# UNITED STATES PATENT AND TRADEMARK OFFICE

**Advisory Action  
Before the Filing of an Appeal Brief**

10/702,198

WALKER ET AL.

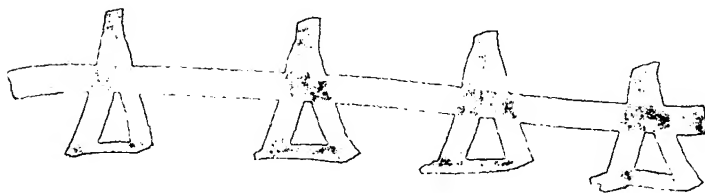
Continuation of 11. does NOT place the application in condition for allowance because: the dashed lines were not intended to represent axis lines, but to show 4 curved sidewalls convex to the interior (the 4 sections each "enclosed" by each dashed line) and 4 rounded corners concave to the interior ( the four sections remaining and not enclosed by the 4 dashed lines). The axis bisecting the side walls and the axis bisecting the corners would be drawn thru 2 opposite corners and 2 opposite sidewalls. Examiner notes that "substantially symmetrical" can include an exact mirror image that is rotated 180 degrees, as is the case of the symmetry of the sides bisected by the axis bisecting the interior through 2 corners. See attached for axis lines..

axis three sidewalls

axis three corners
